Preliminary Consultation
MONTGOMERY COUNTY HISTORIC PRESERVATION COMMISSION
STAFF REPORT

Address:	22200 Clarksburg Road, Clarksburg	Meeting Date:	4/28/2021
Resource:	Master Plan Site #13/25 <i>Cephas Summers House</i>	Report Date:	4/21/2021
Applicant:	Pulte Homes (Randall Rentfro, Agent)	Public Notice:	4/14/2021
Review:	Preliminary Consultation	Tax Credit:	N/A
Case Number:	N/A	Staff:	Michael Kyne
Proposal:	Demolition and reconstruction

Figs. 2-4: October 1992 photographs depicting multiple small rear additions, Historic Preservation Office Archives.

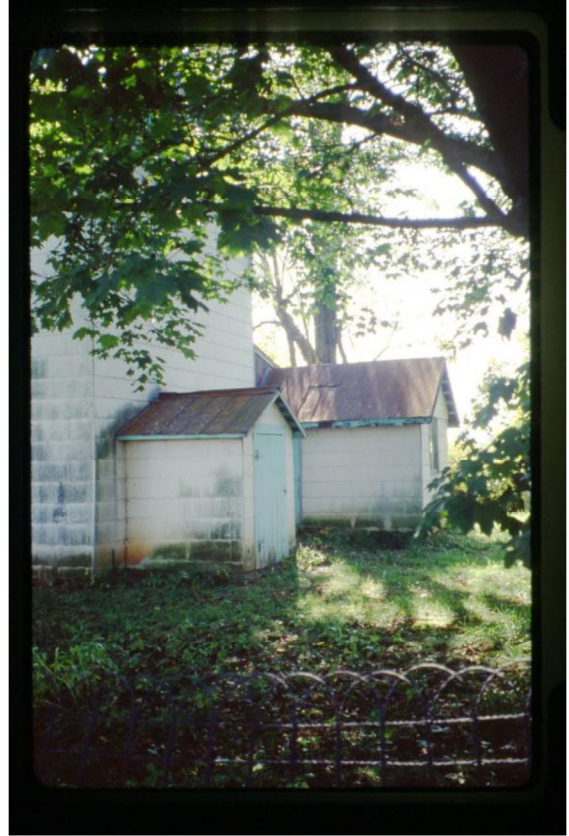
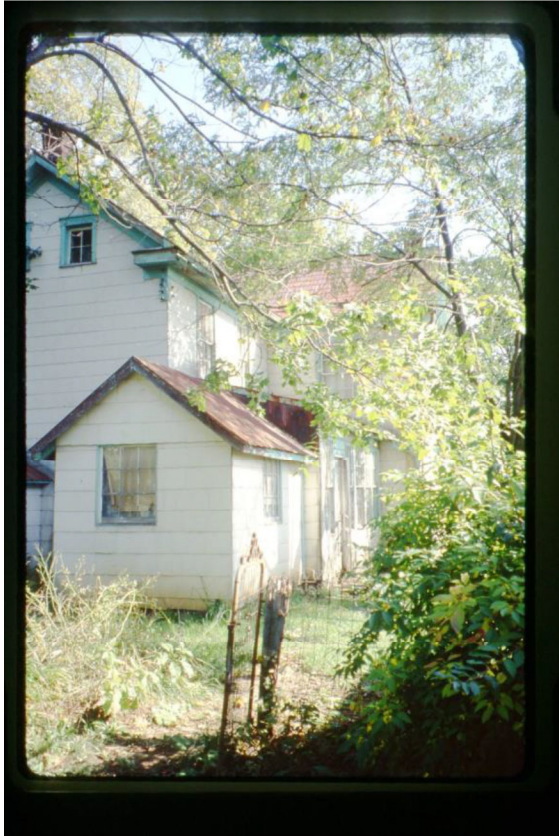
The applicants have returned with a revised proposal, which responds to the Commission's comments and recommendations. The proposed revisions include:

- The proposed new building will be within the existing footprint instead of being located slightly to the southwest.
- The proposed new building retains the traditional ell form of the historic house.
 - The proposed fenestration of the new building is generally consistent with the historic house.
- A window is proposed in place of a door on the south (left) elevation of the rear ell.
- Additional space is proposed via telescoping building additions at the west (rear) of the rear ell.
- A one-story addition is proposed along the south (left) side of the rear ell, where there is currently a one-story open porch.
- The proposed new two-car garage has been redesigned to be more compatible with rural outbuildings.

Fig. 6: Removed window indicated by the red rectangle.

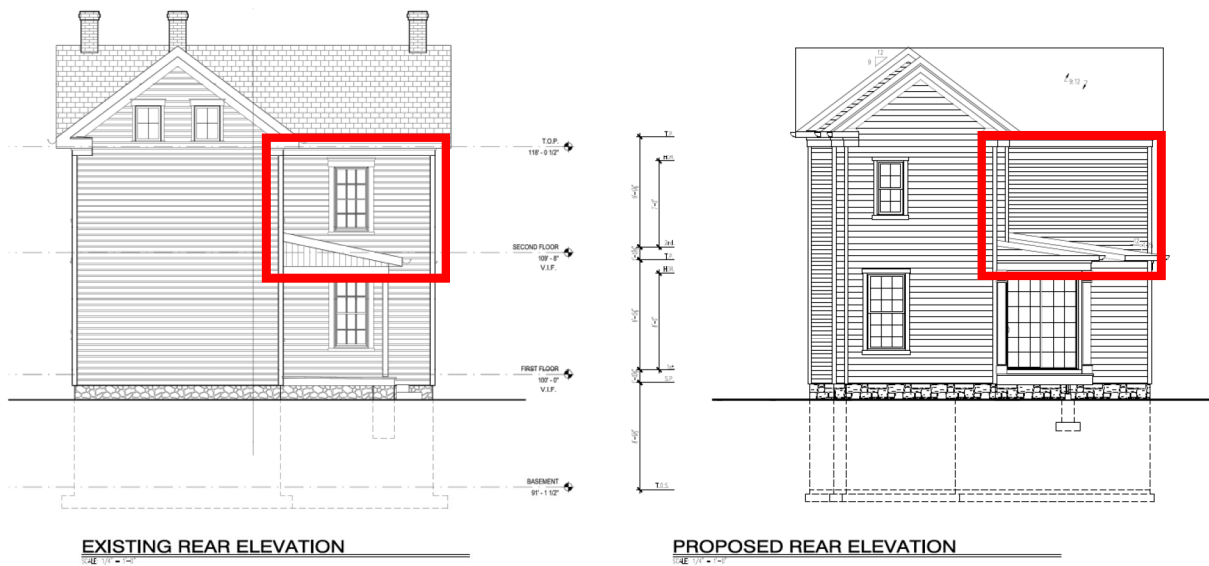
- Consider reintroducing the window on the second floor of the west (rear) elevation above the proposed one-story addition (see Fig. 6).

EXISTING RIGHT SIDE ELEVATION

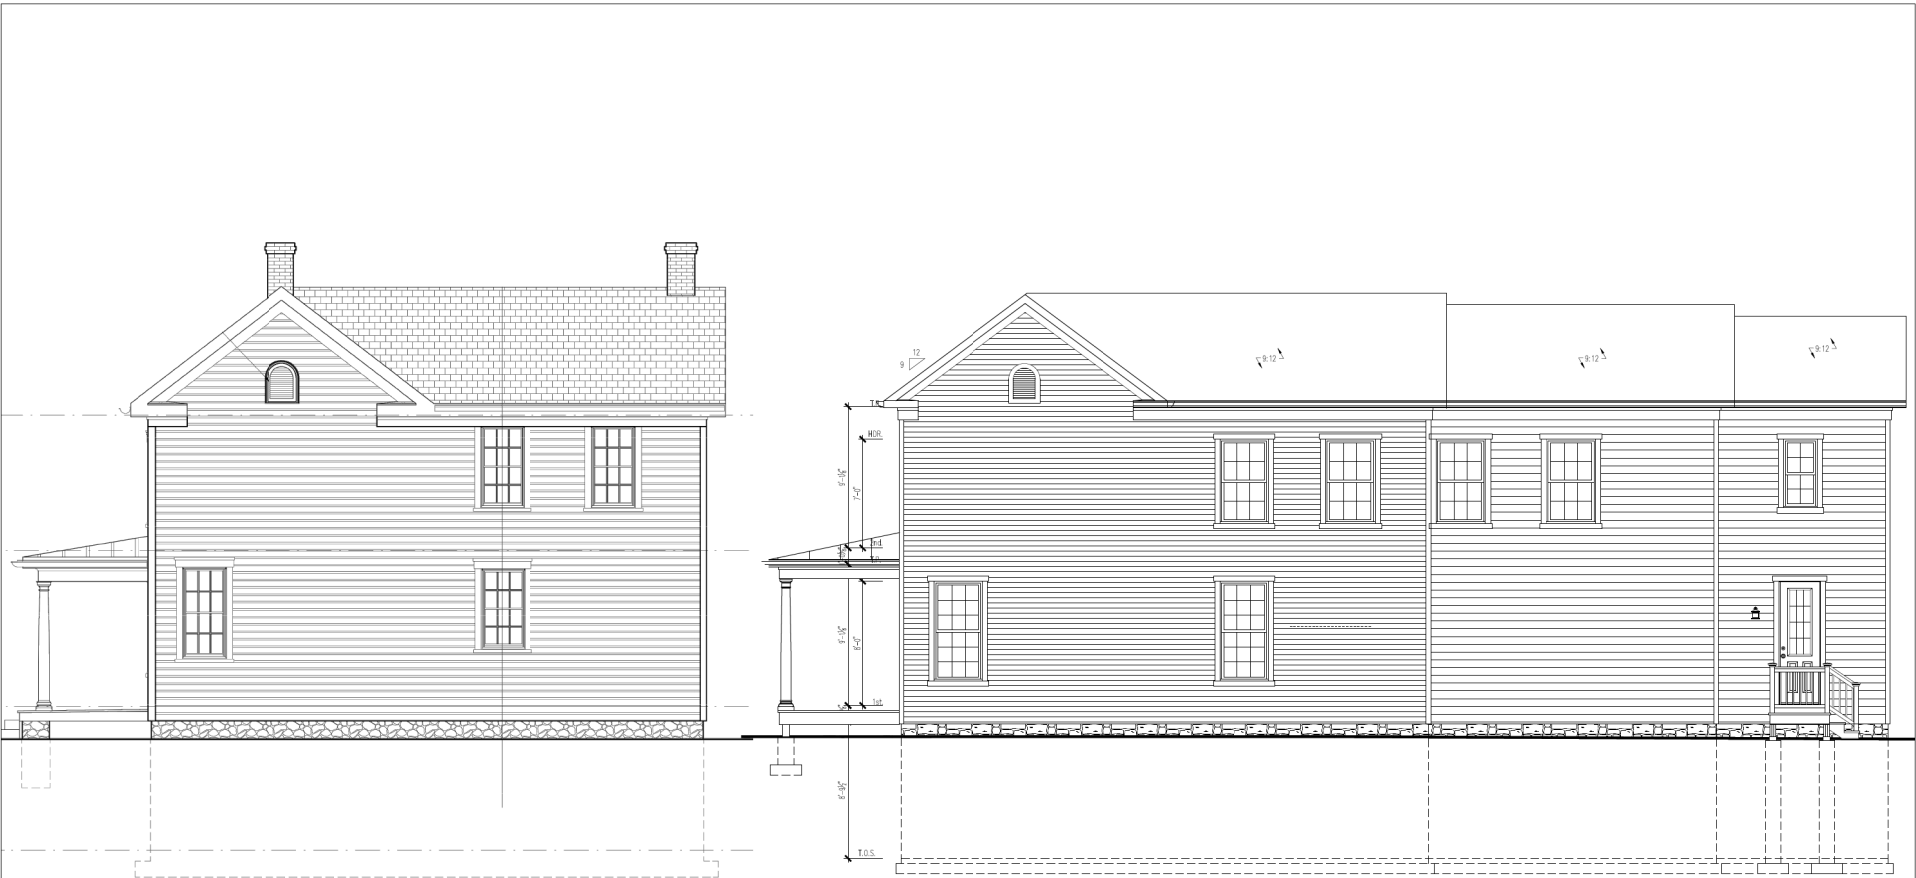
- Explore adding fenestration on the first floor of the north (right) elevation of the telescoping addition (see Fig. 5).
 - Currently, there is a blank exterior wall in this location, as the intention is to provide cabinets on the interior.

Fig. 5: Blank wall indicated by the red rectangle.
